# Addendum No. 2

**PROJECT:** Vivie Nelson Care Center Renovation, Alexandria, MN

**From:** Wold Architects and Engineers

**Subject:** Addendum No. 2 for Bidding Documents for the
**Vivie**
**Nelson Care Center Renovation**
**Alexandria, Minnesota**

# M3.02c

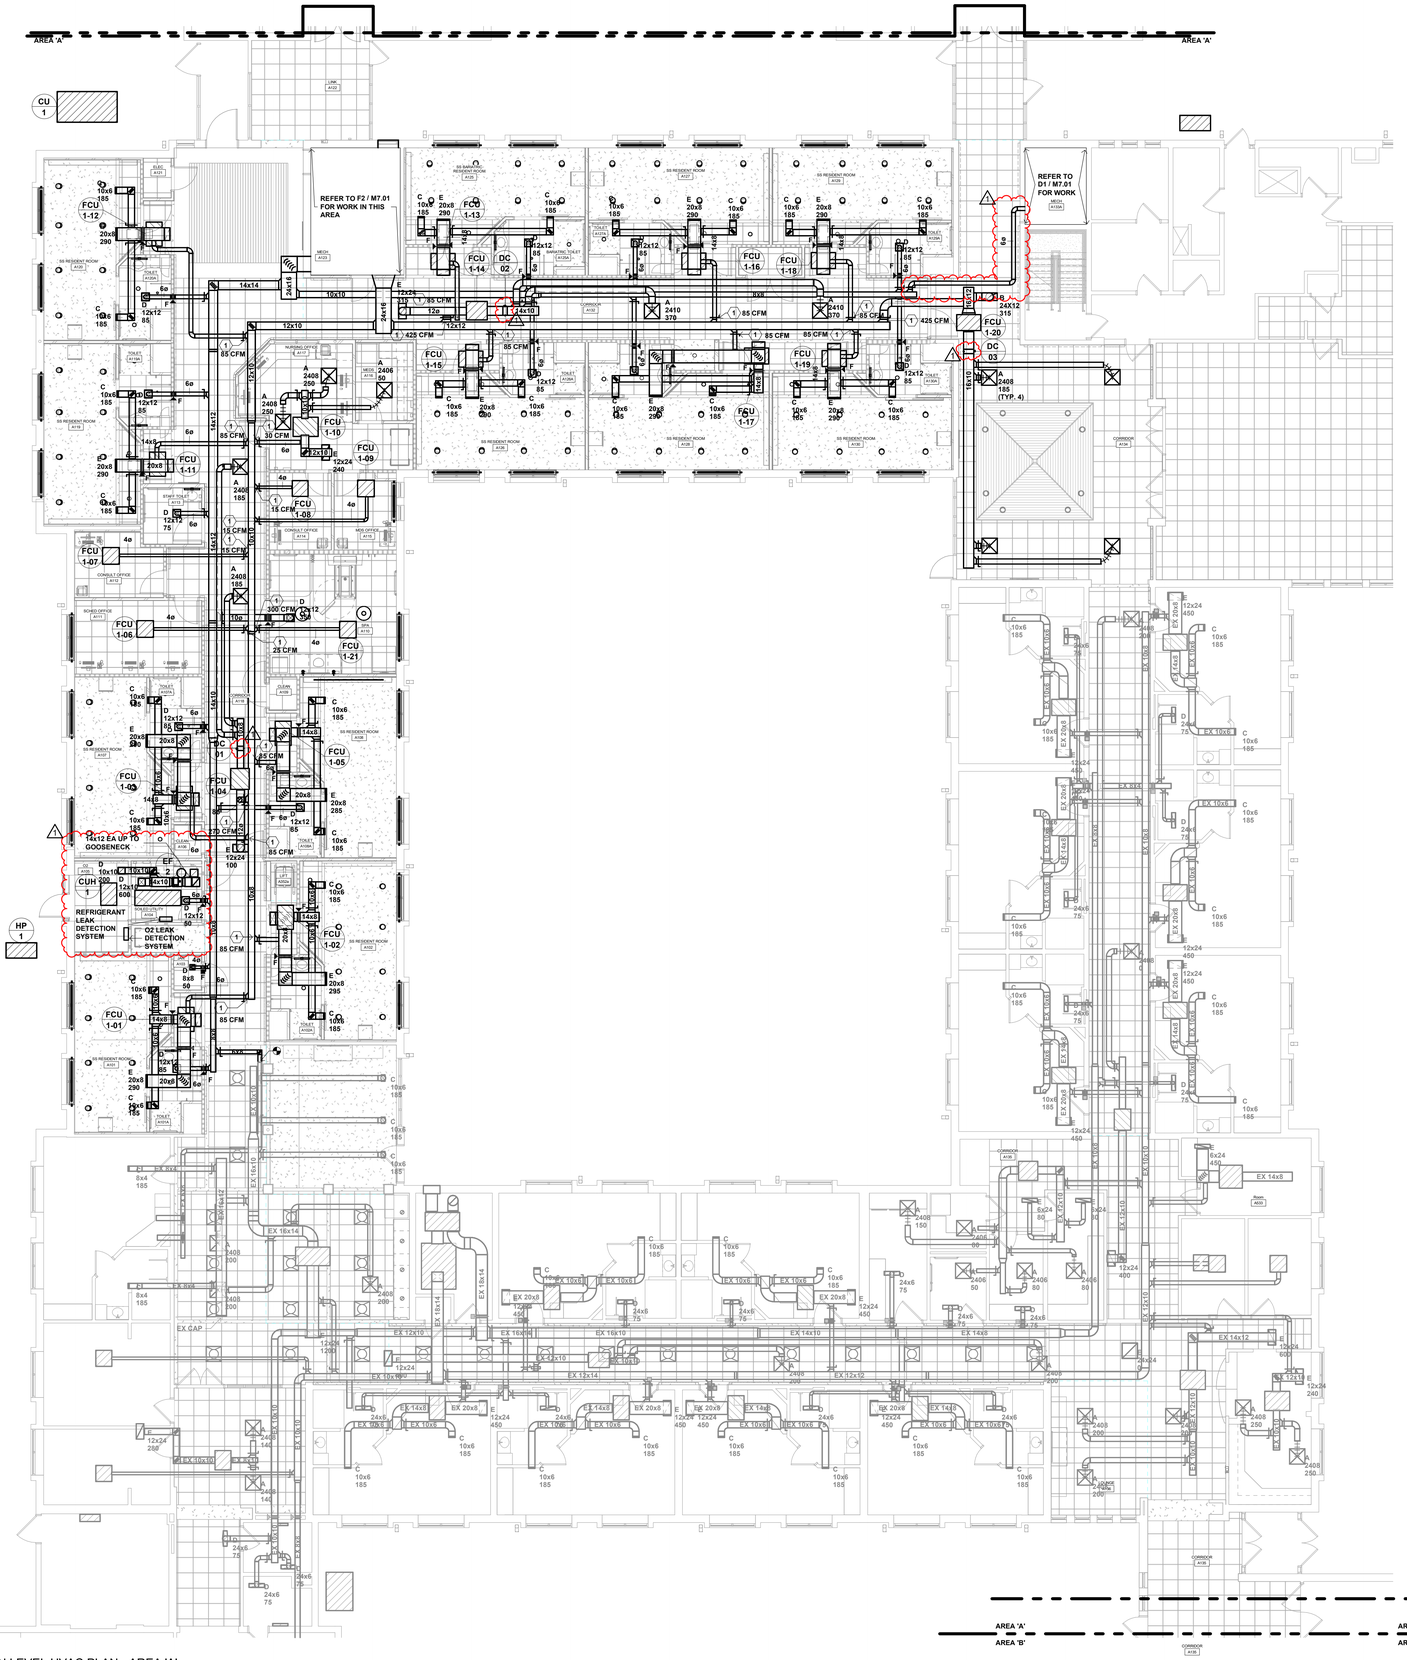
A. **Reissued this addendum**
      i. Revised finned tube piping layout, control valve locations, and updated overall hydronic sizing.
29. **DRAWING M4.02a - MAIN LEVEL HVAC PLAN - AREA 'A'**

# M4.02a

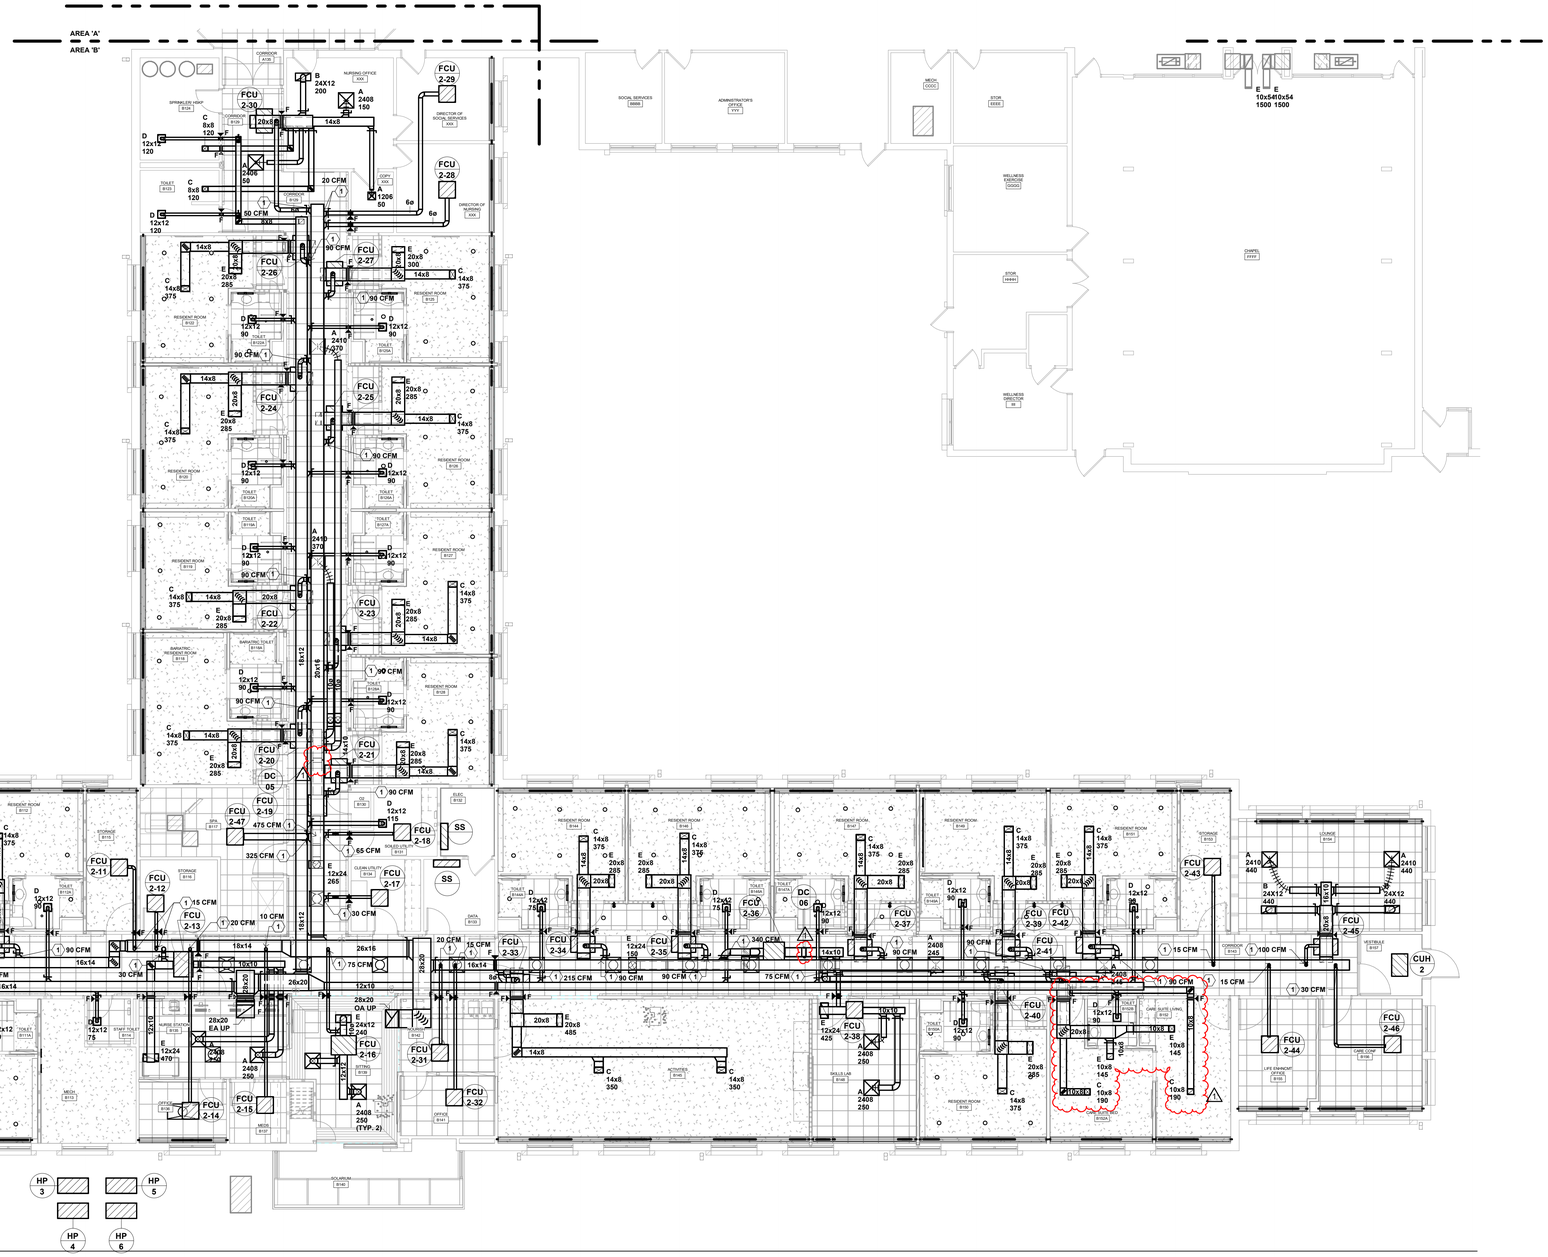
A. **Reissued this addendum**
   i. Duct coils connected to FCU ductwork. Refrigerant leak detection and exhaust added to mechanical rooms.

# M4.02b

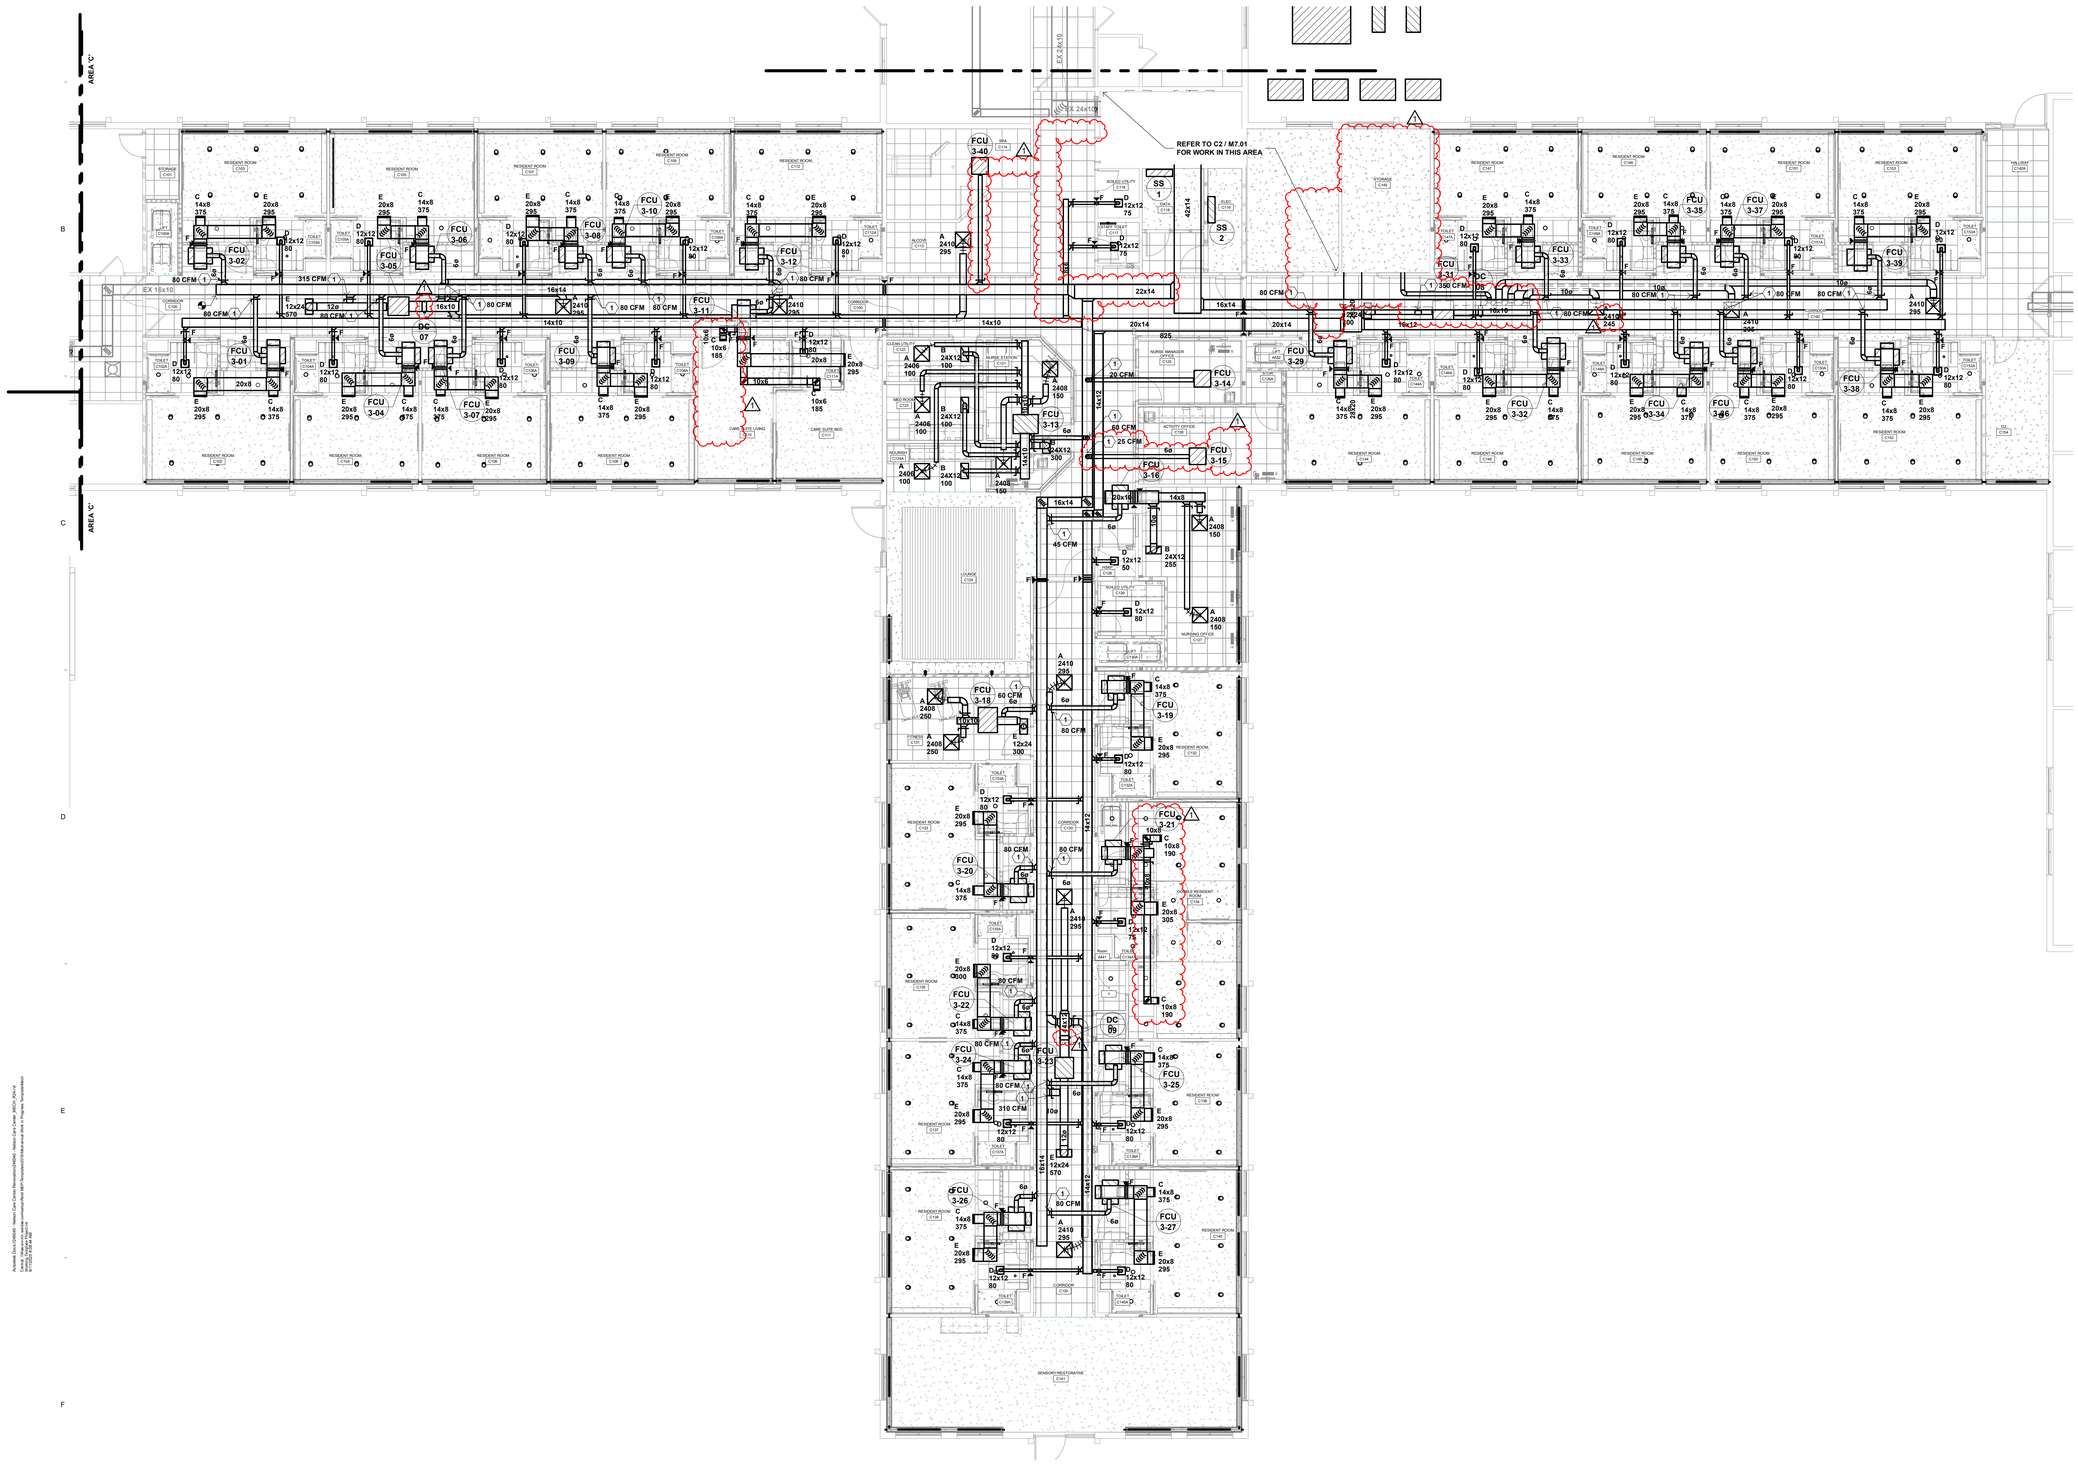
30. **DRAWING M4.02b - MAIN LEVEL HVAC PLAN - AREA 'B'**
    A. **Reissued this addendum**
       i. Duct coils connected to FCU ductwork. Adjusted ductwork and added ventilation to Care Suite Living B152.

**M6.00**

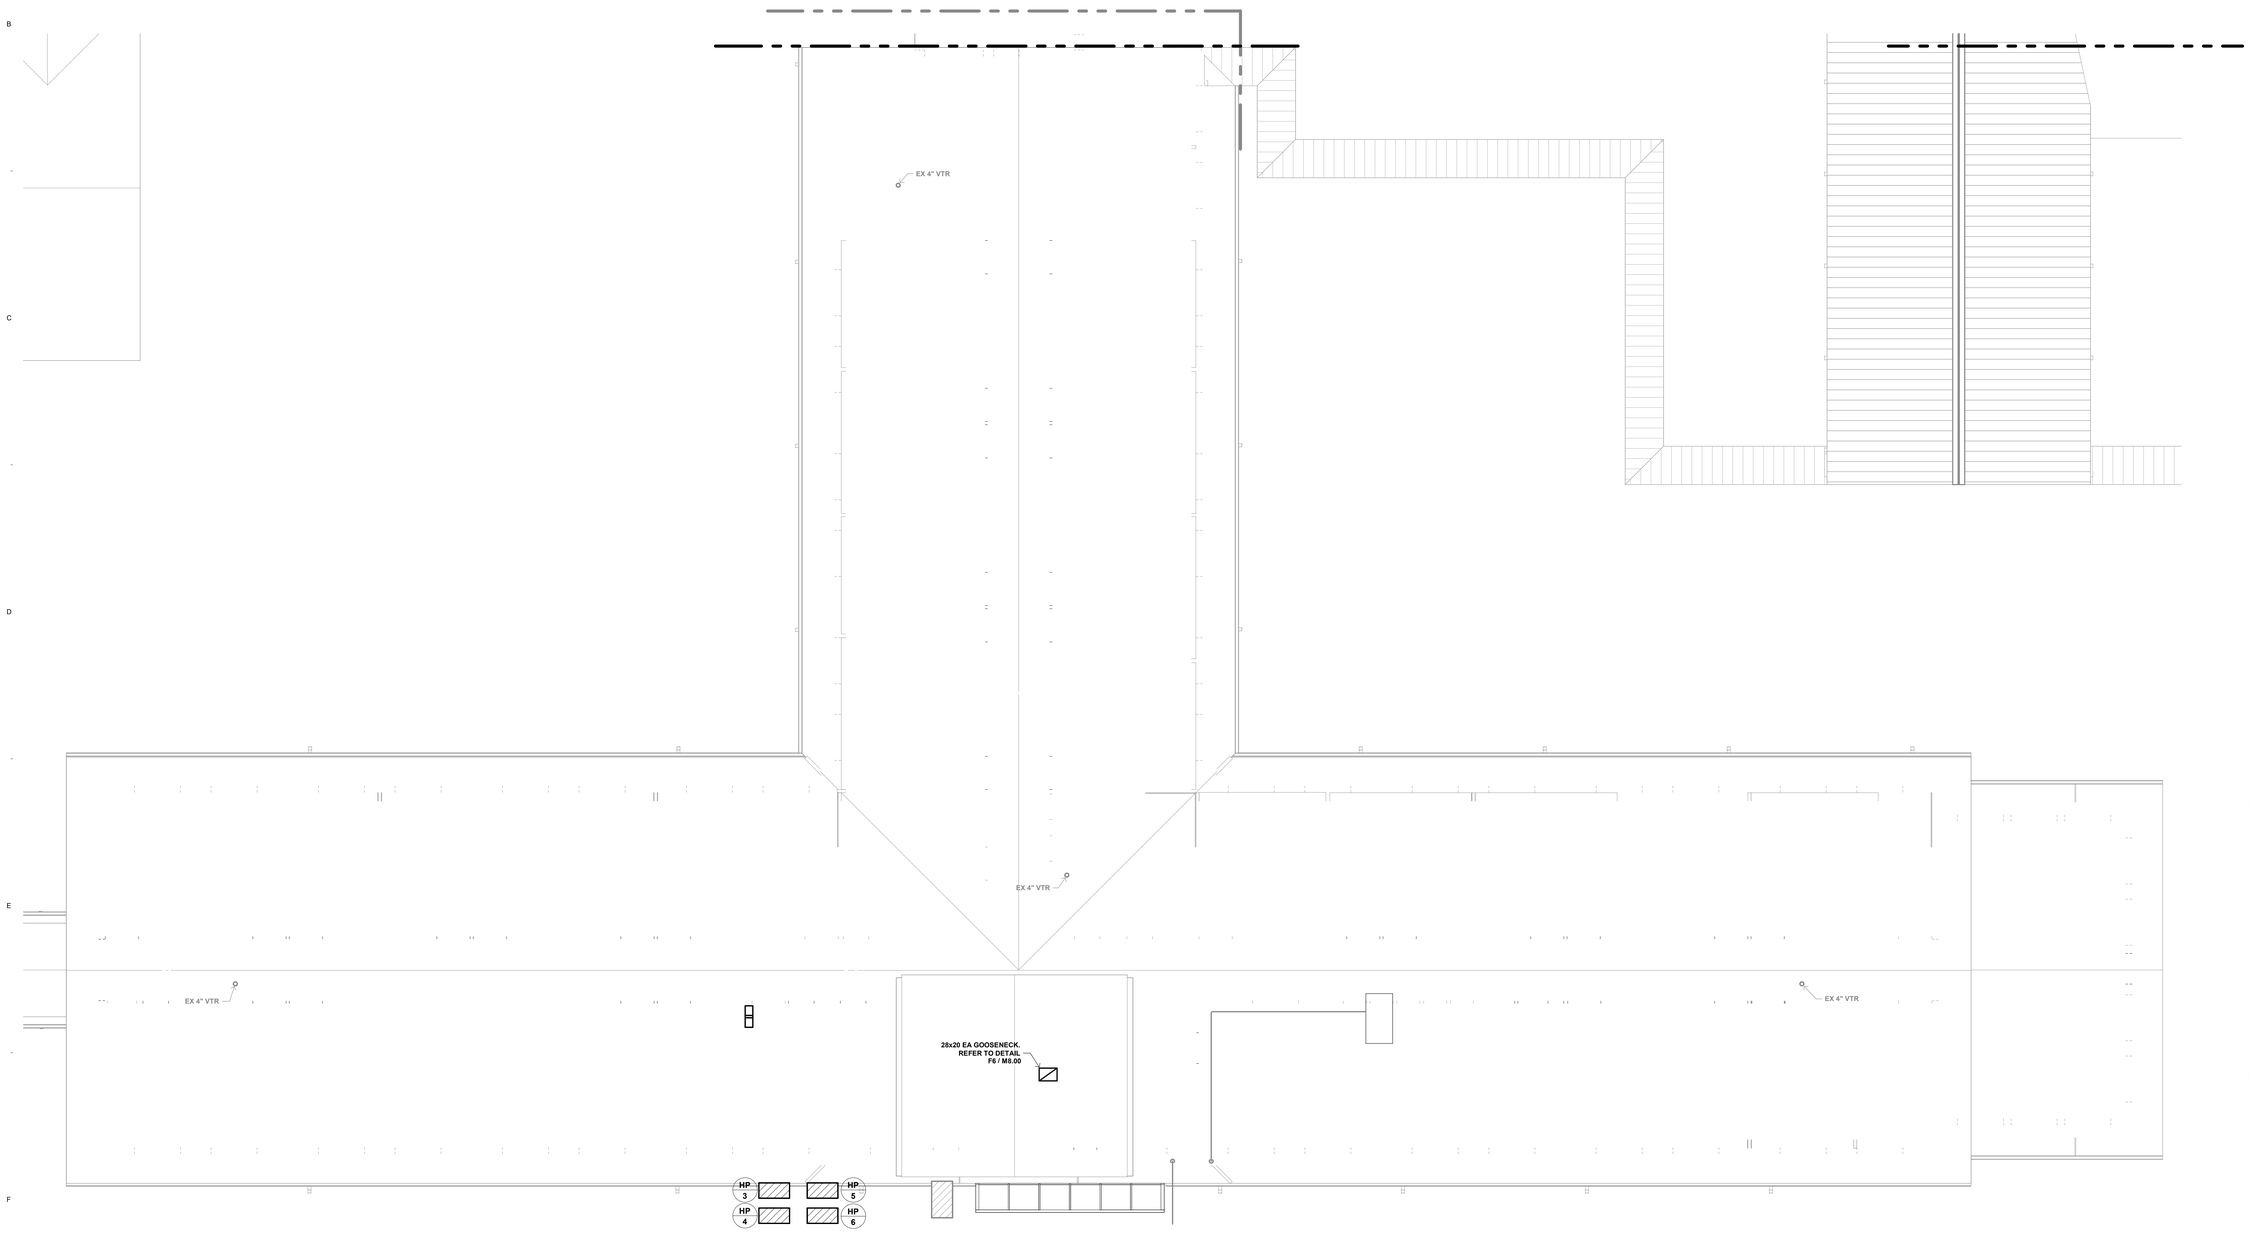
32. **DRAWING M6.00 - ROOF PLAN - AREA 'A'**
    A. **Reissued this addendum**
       i. Roof plan adjusted to show only area 'A' at 1/8" = 1'0" scale. Roof plan tags and ductwork cleaned up.
